**Western Nuclear, Inc.
Sherwood Project
Wellpinit, Washington**

**SHERWOOD TAILING
RECLAMATION PLAN**

RESPONSES TO NRC COMMENTS

Subject: Responses to NRC Staff Comments (Dated May 19, 2000) on the Termination Finding of the Western Nuclear, Inc.'s Sherwood Uranium Mill License Submitted by the Washington State Department of Health

FIGURE C.4.2
INTERPRETED BEDROCK
SURFACE CONTOUR

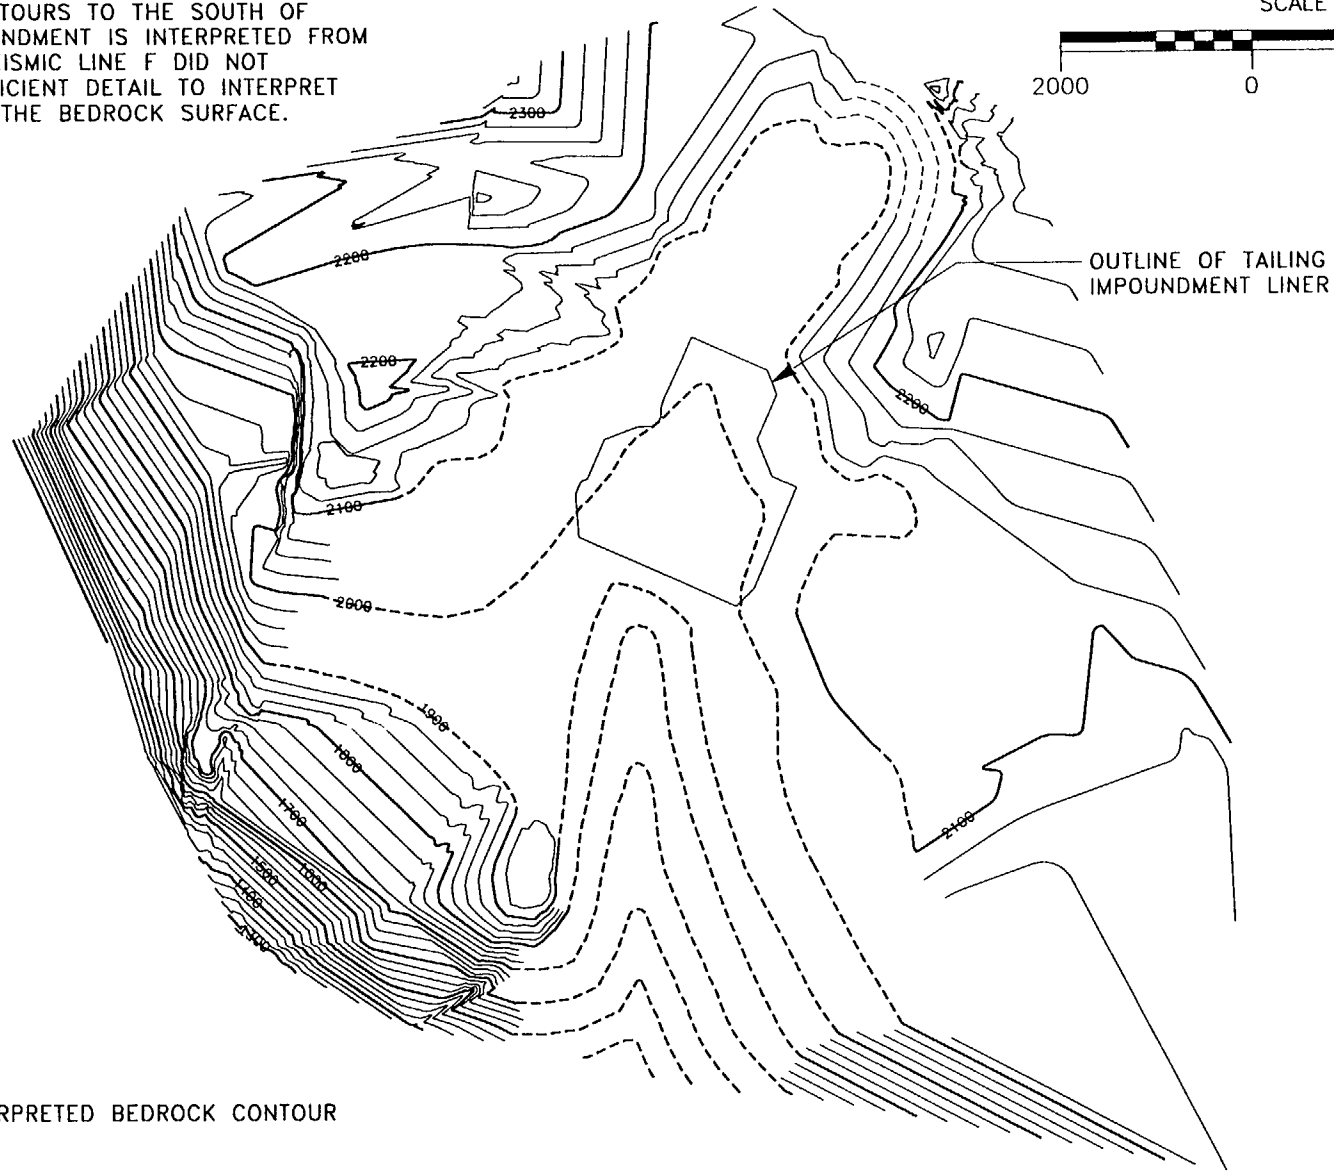
The contour intervals on Figure 3.4 indicate a level of detail that is not supported by the seismic information. Elimination of the 20-foot contour interval on the figure could better represent the bedrock surface. It should be noted that the bedrock contours in the vicinity of seismic line F were based on outcrops. (Seismic line F could not be interpreted.) The text could also be enhanced by documenting that the new downgradient monitoring wells were installed. This is significant, considering the need to have good control at the Point of Compliance downgradient from the tailings impoundment.

The contour intervals on Figure 3.4 indicate a level of detail that is not supported by the seismic information. Elimination of the 20-foot contour interval on the figure could better represent the bedrock surface. It should be noted that the bedrock contours in the vicinity of seismic line F were based on outcrops. (Seismic line F could not be interpreted.)

The 20-foot contour intervals have been removed from Figures 3.4 and C.4.2 of Appendix P to the December 1994 TRP as requested and replacement figures are included with this transmittal. A note has been added to revised Figures 3.4 and C.4.2 noting that, due to insufficient resolution of the seismic data in these areas, the bedrock contours in the vicinity of seismic line F were based on outcrops

NOTE:
BEDROCK CONTOURS TO THE SOUTH OF
TAILING IMPOUNDMENT IS INTERPRETED FROM
OUTCROPS. SEISMIC LINE F DID NOT
PROVIDE SUFFICIENT DETAIL TO INTERPRET
LOCATION OF THE BEDROCK SURFACE.
